Date: 23/11/2018	Page: 1/3	N°: BT-18-003-EN
TO ALL OUR DEALERS		
Attention:	Technical and Commercial Department	
From:	Customer care Department

TECHNICAL BULLETIN -18-003-EN**NEW PACKAGING FOR BIANCA PL162T MACHINE**

Please note that starting from machine serial number 182055 we have implemented a new packaging for Bianca PL162T machine.

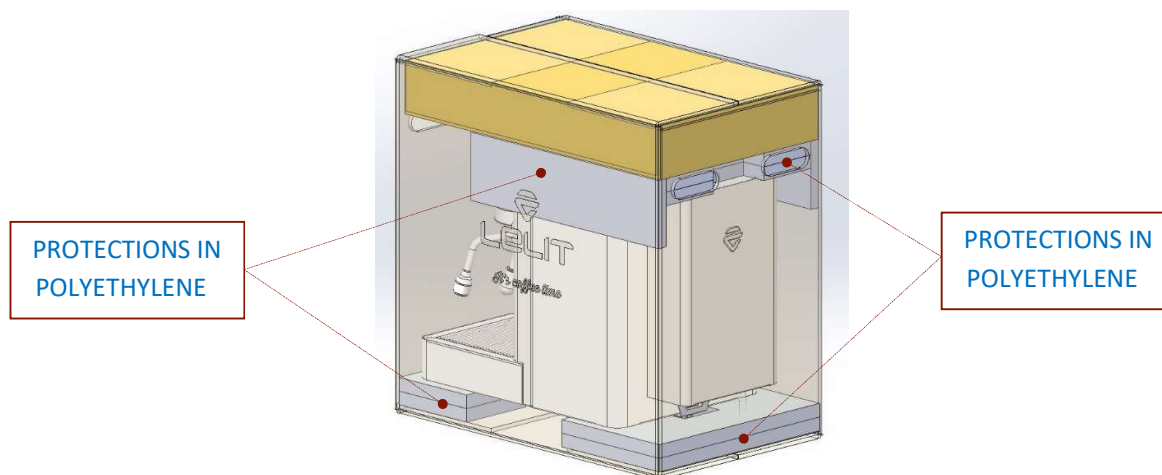
- 1- To make the handling and the transport easier, the pallet has been eliminated, a triple wall extra box with side handles has been added.

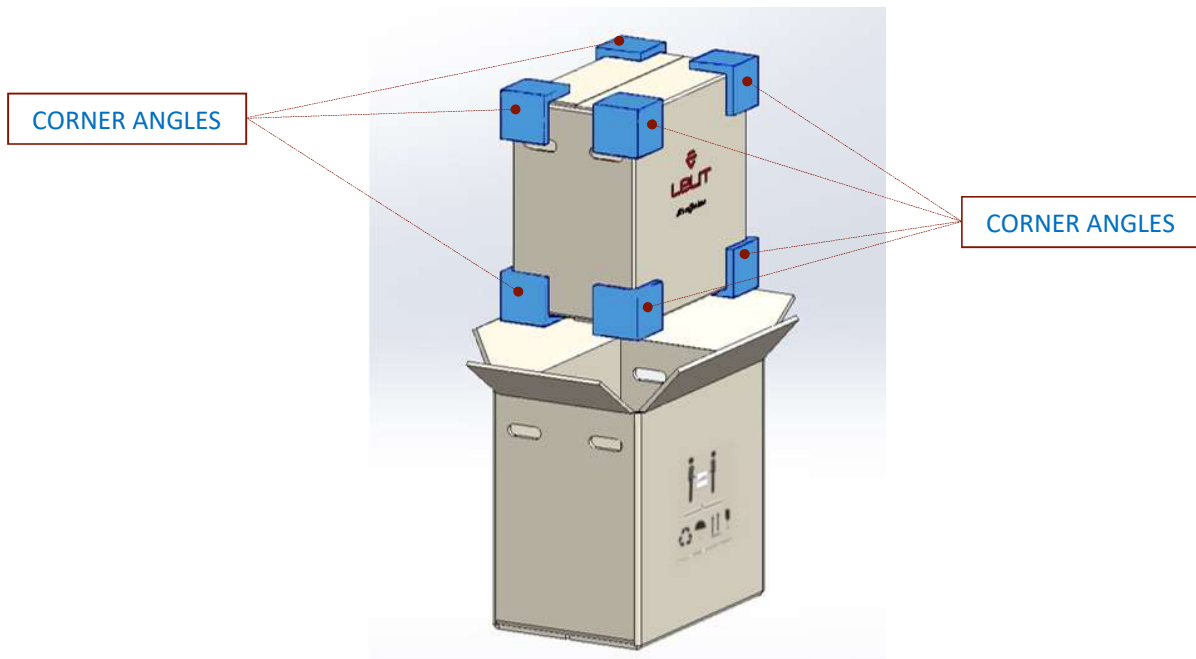
- 2- The internal protections, which previously were in Polystyrene, are now made of Polyethylene, a water proof material with higher shock absorption and a better elasticity, therefore particularly suitable to protect the machine against any possible impact.

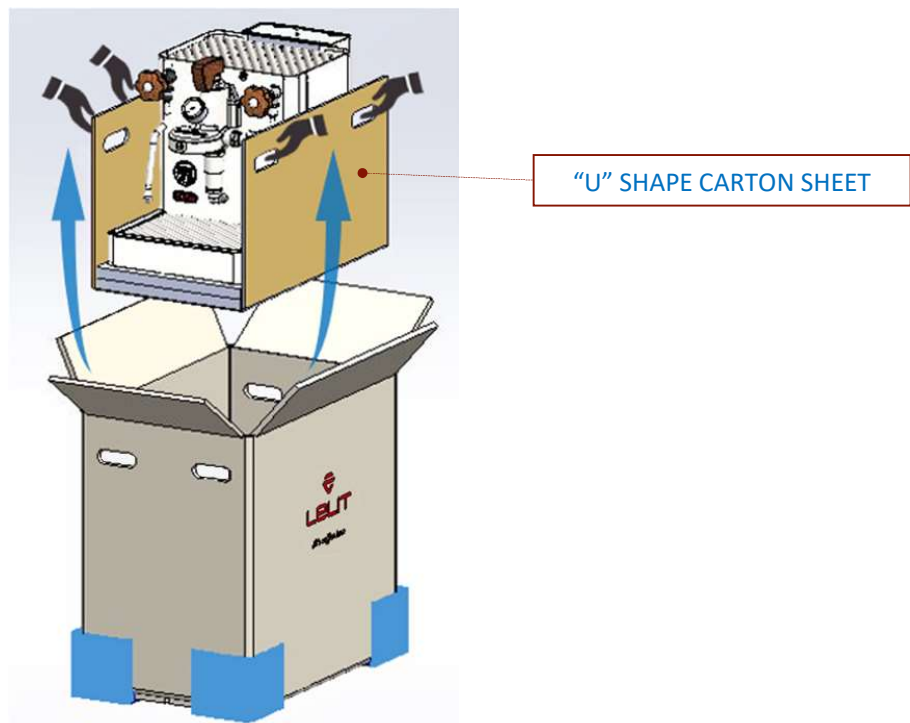
3- 8 corner angles in polyethylene have been inserted to space out the inner box from the overpack.

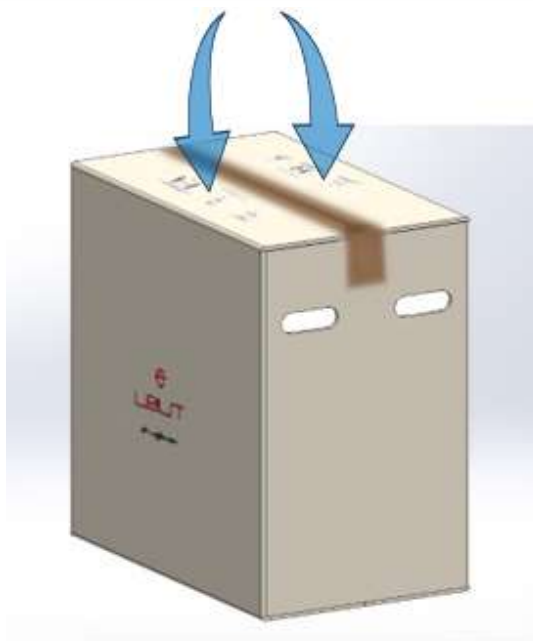
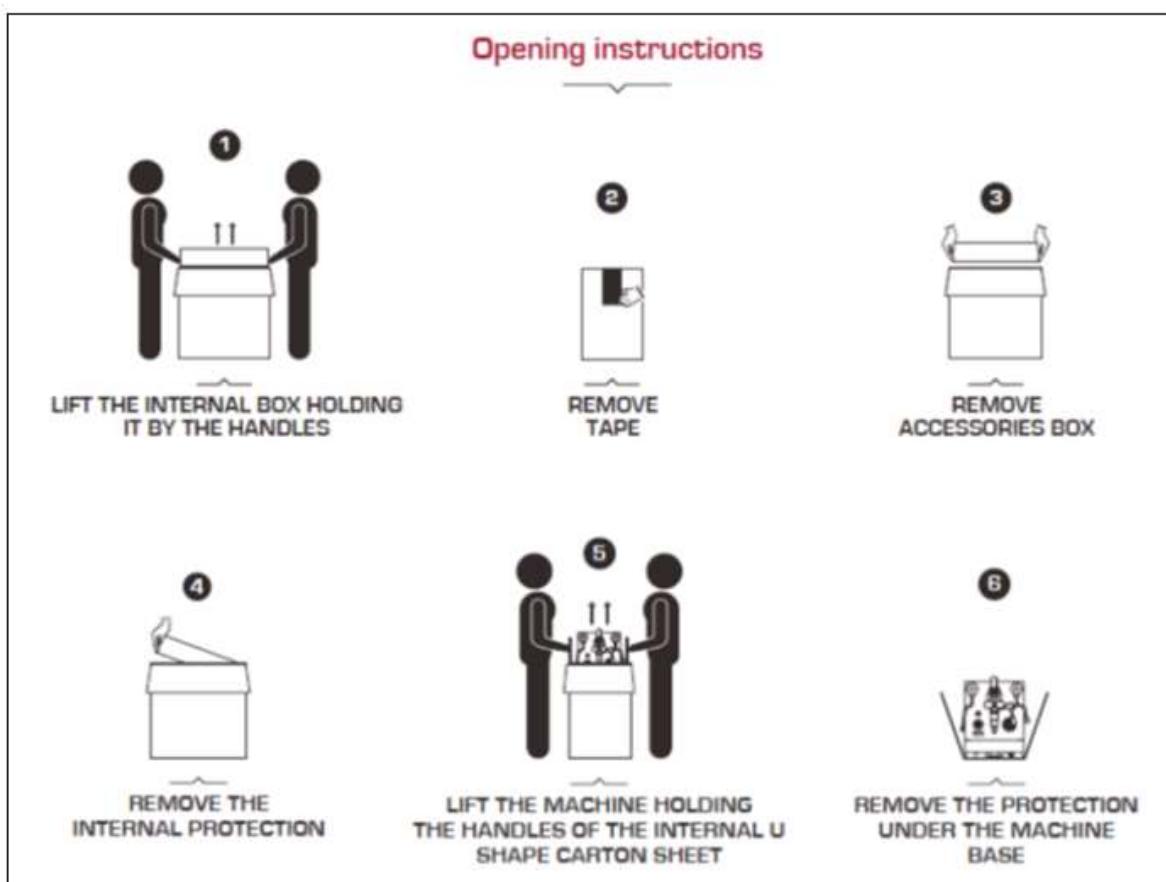
4- An internal "U" shape carton sheet with handles has been designed to lift the machine and remove it from the box easily.
